Technical Service Information

SATURN NEW SHIFT FORK/REVERSE GEAR FOR 91&92 MODEL

Figure 1

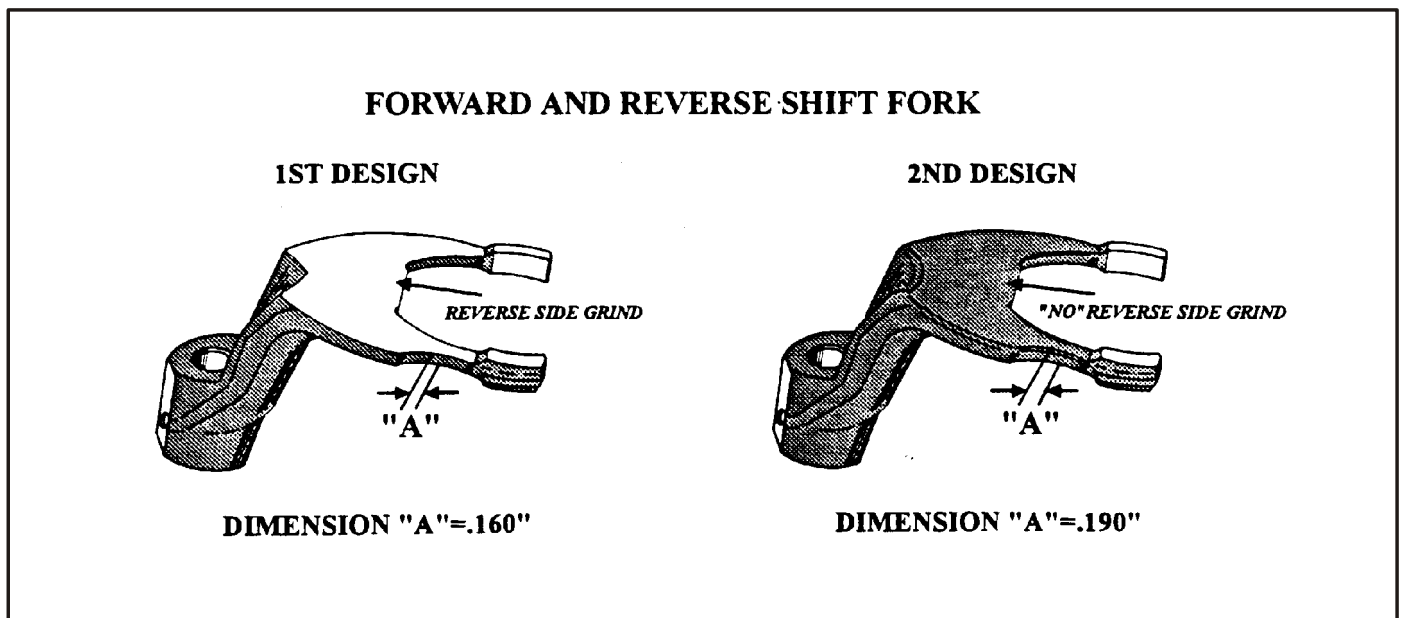
(1) Forward and Reverse Shift Fork:

1st Design (91&92) - has a "Reverse side grind" and the Fork thickness is approximately .160".

NOTE: 1st design Fork is no longer serviced. (See Figure 1) 2nd design (93) - has "NO" "Reverse side grind" and the Fork thickness is approximately .190". (See Figure 1)

Figure 2

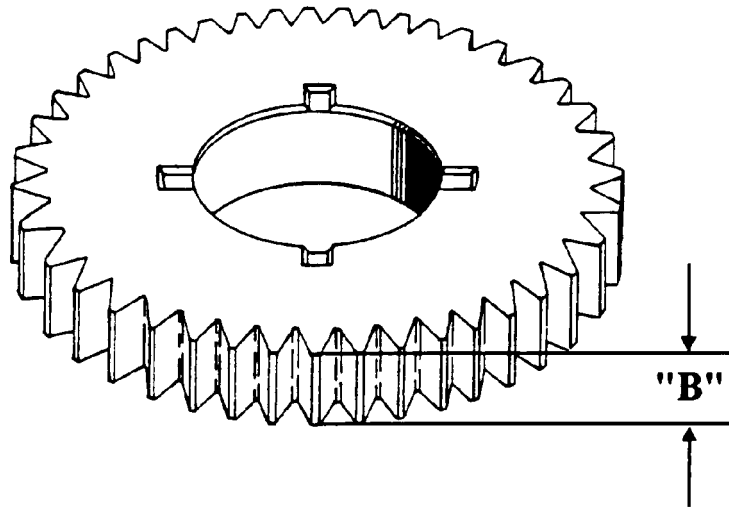
(2) Reverse Driven Gear:

1st Design (91&92) - the thickness of the gear is approximately .512".

NOTE: 1st design Reverse gear is no longer serviced. (See Figure 2)

2nd Design (93) - the thickness of the gear is approximately .449". The increase in the Fork thickness made it necessary to reduce the thickness of Reverse gear. (See Figure 2)
